Staff Summary Report

SUBJECT: Hold a public meeting for a Development Plan Review for **EAGLE ENGINEERING** located at 735 West Knox Road.

COMMENTS: Request by **EAGLE ENGINEERING (PL090318)** (Geoffery Bergauer, Eagle Engineering, Inc., property owner; Brian Bradley, Laurshan, Inc., applicant) for a 7,000 s.f. building addition to an existing plastics fabricating and warehouse facility. The proposed building area is 27,300 s.f. overall. The 1.61 acre site is located at 735 West Knox Road in the General Industrial and Southwest Overlay District. The request includes the following:

DPR09193 – Development Plan Review including site plan, building elevations, and landscape plan.

1"=20'-0" SITE PLAN
SEE ALSO CIVIL DRAWINGS COVER SHEET

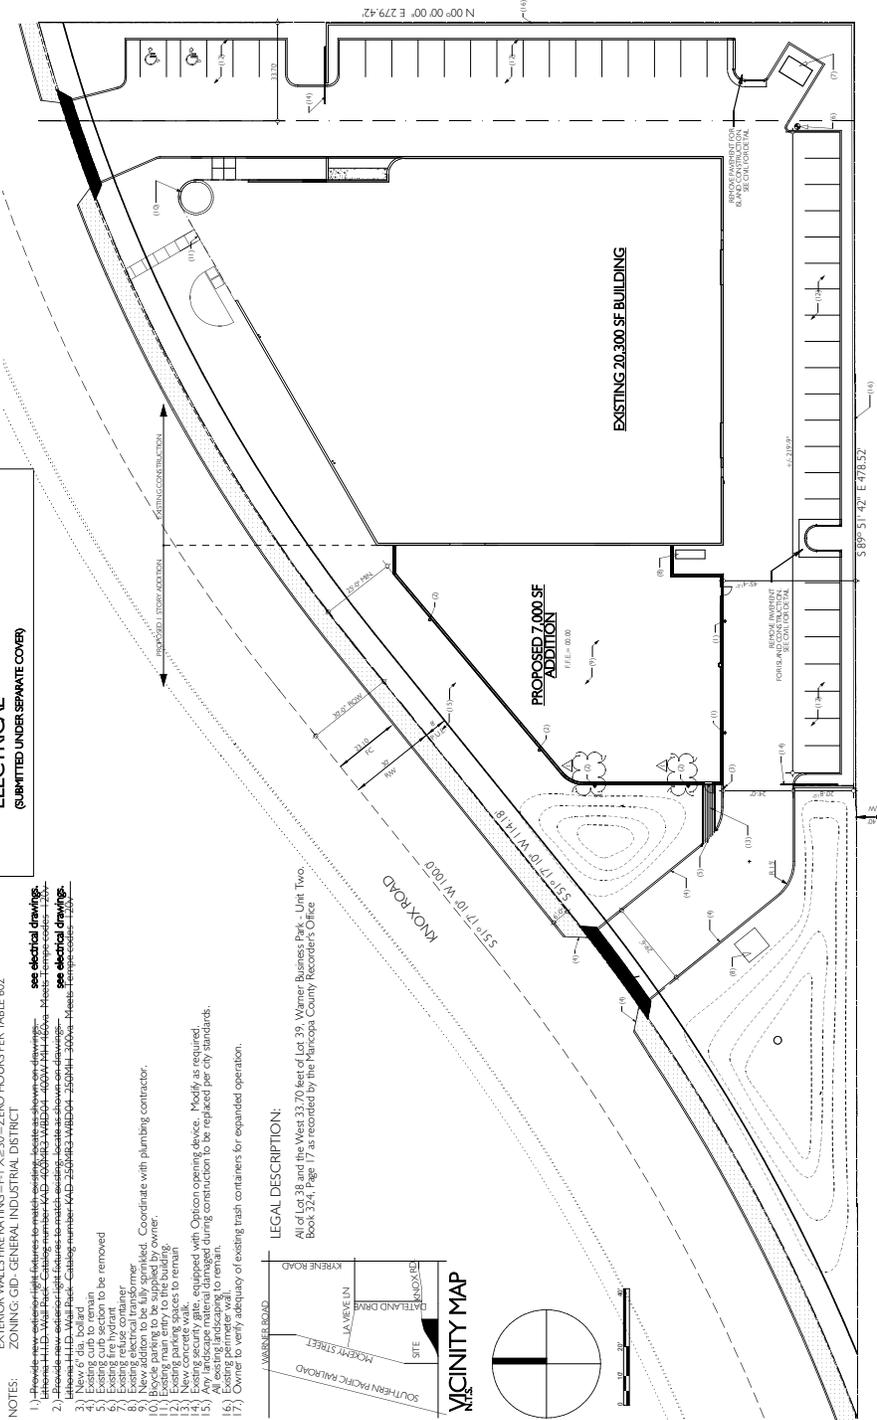
2. Provide upgraded paving at each driveway apron. Extend upgraded paving in the driveway from the back of the accessible public sidewalk bypass to 20'-0" on site and from curb to curb at the drive edges. Where a portion of the paving extends into the public right-of-way, provide upgraded paving of concrete or clay unit paving. Cast-in-place concrete paving may be substituted if the paving is entirely on site. Detail paving and substrate installation to withstand heavy truck traffic.

3. Paint utility equipment boxes such as the transformer to match the coloring of the building.
4. Place exterior, freestanding reduced pressure and double check backflow assemblies in pre-manufactured, pre-finished, lockable cages (one assembly per cage). If backflow prevention or similar device is for a 3" or greater water line, delete cage and provide a smooth face center score CMU screen wall following the requirements of Standard Detail T-214.

1"=10' COMPOSITE FIRST FLOOR PLAN

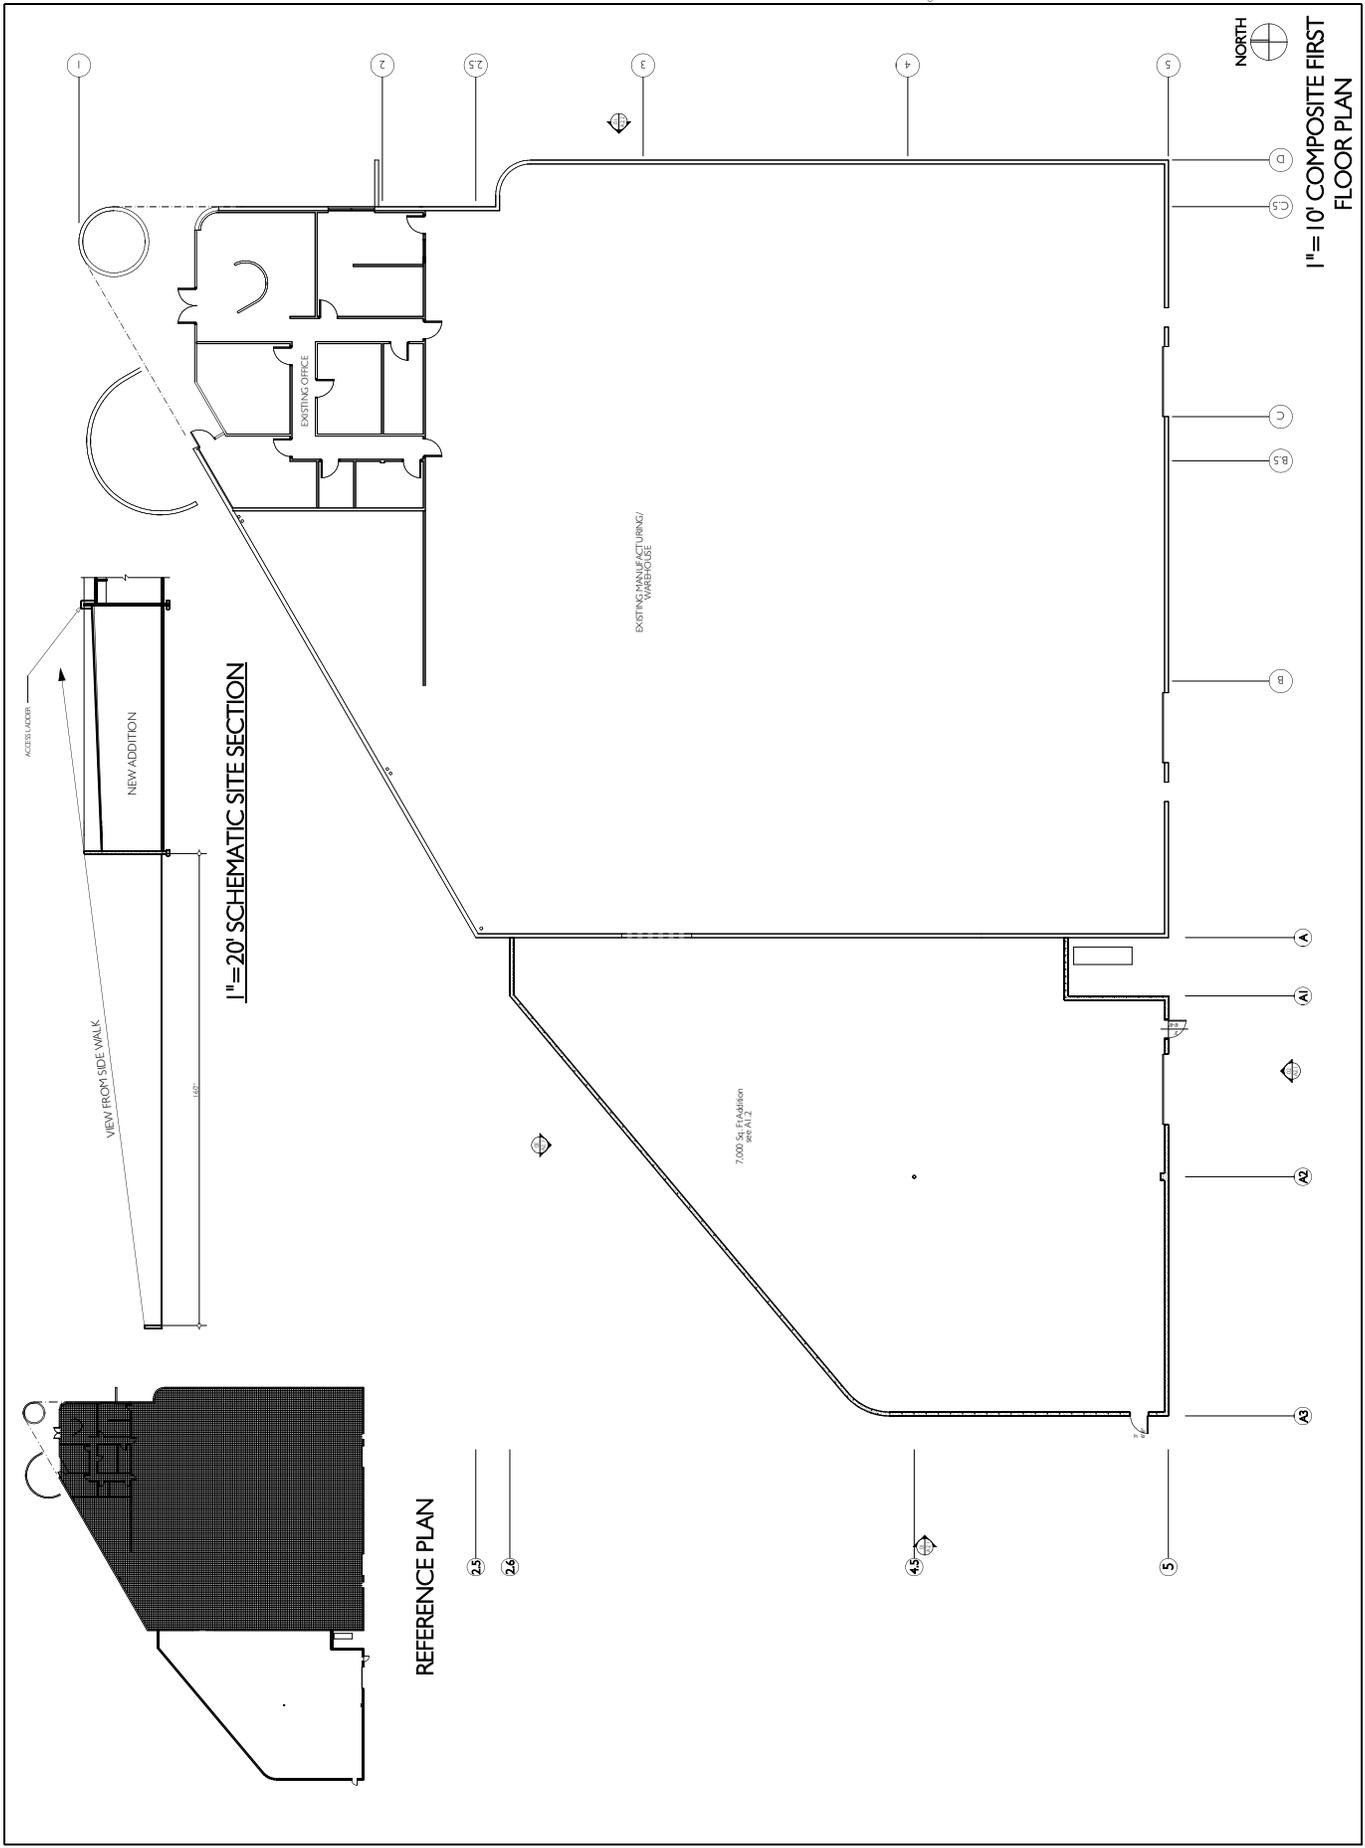
6. Identify mezzanine or indicate no mezzanine in building or addition.
7. Verify minimum clearance requirements for existing service entrance section that remains and is located at southwest corner of original building. Surface mount conduit is allowed around the S.E.S. in the alcove that is created by the addition. Surface mount conduit may not extend outside of the alcove or be located more the 5'-0" above the S.E.S. within the alcove. Paint S.E.S. cabinet and exposed conduit that is allowed a gray color to match the CMU of the building.

A2.1

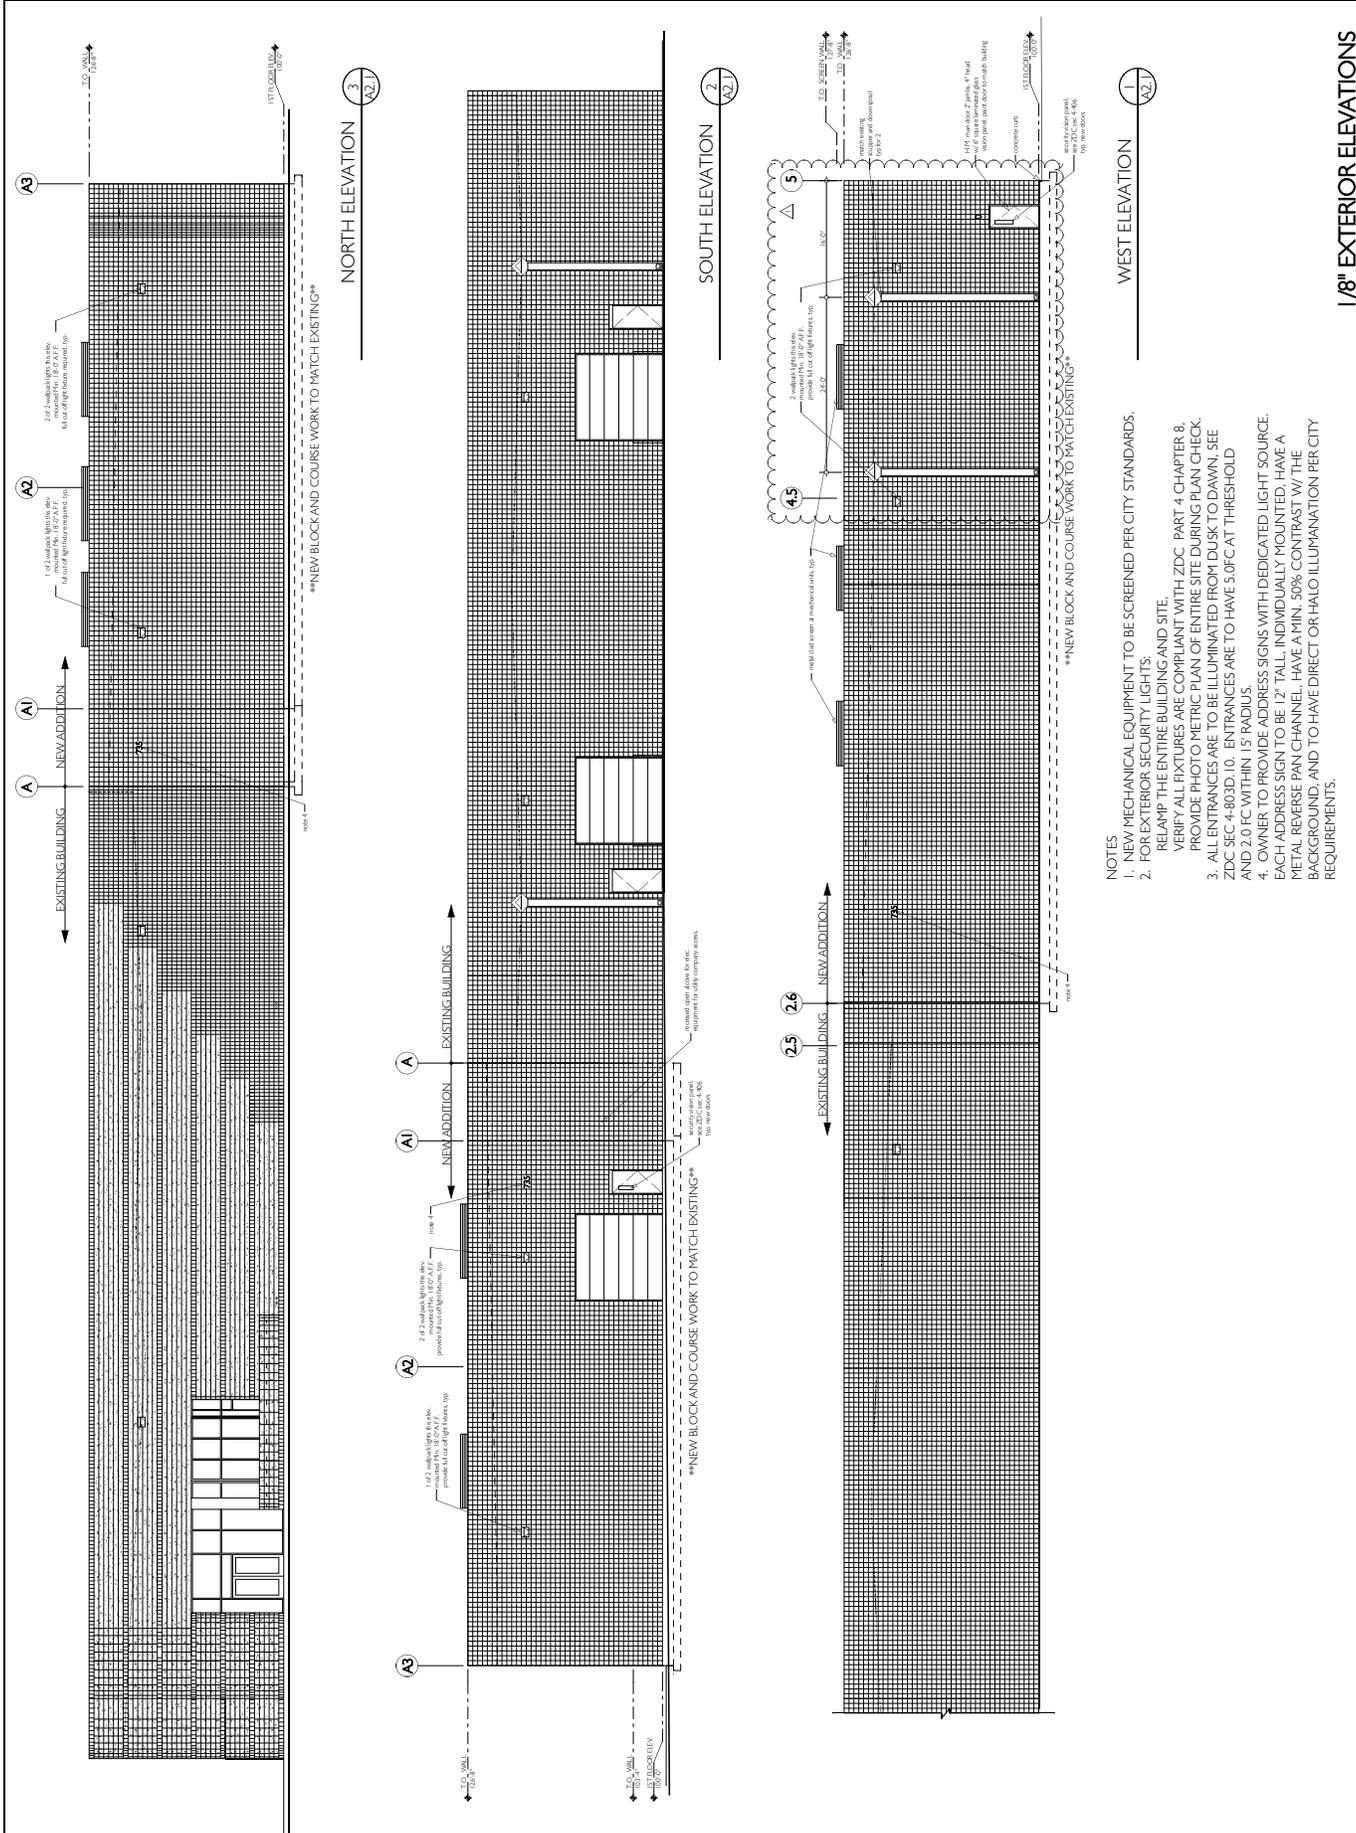
8. The materials and colors are approved as presented:
Exposed Smooth-faced CMU – 8x8x16 center score: gray. Match color or original block or paint the entire building for a uniform masonry tone.
Steel doors and frames, exposed metal work such as downspout and screens: gray – Sherwin Williams "Krypton" SW6247
Provide main colors and materials with a light reflectance value of 75 percent or less. Specific colors and materials as listed above are approved by planning staff. Submit additions or modifications for review during building plan check process.

9. Screen roof mount mechanical units by one of two means—do one of the following two options:
 - a. Provide roof mount metal corrals around each individual unit as indicated. Indicate material of these screens. The corrals may not be perforated unless there are two panel layers which allow staggering of the perforations. Provide gates in the corrals for an uninterrupted screen, as indicated.

- b. Increase the masonry parapet height of the addition, including the existing wall that is common between addition and existing building, to match or exceed the height of the mechanical units. The height of the north, east and south parapets of the original building may remain without modification.

10. Provide secure roof access from the interior of the building. Do not project roof access ladder above top of parapet. Existing roof access may be used for the addition by means of a finished parapet opening between the existing and proposed roofs. Provide detail of opening in parapet.

11. Match exposed overflows and downspouts to existing construction.
12. Incorporate lighting, address signs, and incidental equipment attachments (alarm klaxons, security cameras, etc.) where exposed into the design of the building elevations. Conduit, piping, or related materials are not permitted to be exposed on the surface of the elevations except (with restrictions) within the S.E.S. alcove. Refer to related Floor plan condition 7.

MASTER PLANT LIST

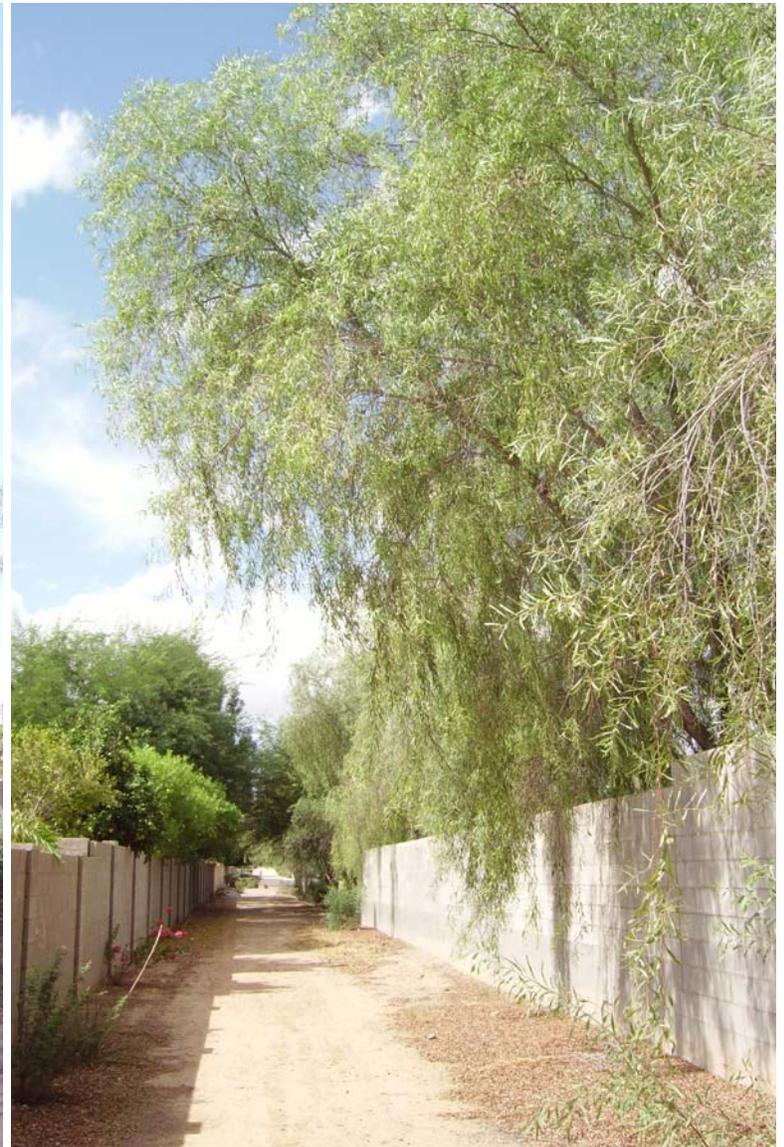
14. Restore plant material on-site and in Knox Road frontage outside of designated "limit of new landscape" areas that have died since 1996 installation, or are alive at this time but are in decline and indicate probability of dying. Use 1995 approved landscape construction document prepared by T.J. McQueen for comparison with current plant layout. A copy of the 1995 landscape plan will be used in the plan check process and in the subsequent planning final inspections at the conclusion of construction.

15. Submit landscape and irrigation construction documents as part of building plan check review process. The plant materials are approved as proposed and specified on the landscape plan. Any additions or modifications may be submitted for inclusion in review during building plan check process.

16. Top dress disturbed planting areas with a decomposed granite application that matches the size and color of existing material on site. Provide decomposed granite application of 2" uniform thickness. Do not introduce river run rock or similar hand size rock for landscape or drainage function unless rock is embedded in a concrete substrate to prevent removal and use for criminal activity. Provide pre-emergence weed control application and do not underlay rock or decomposed granite application with plastic.
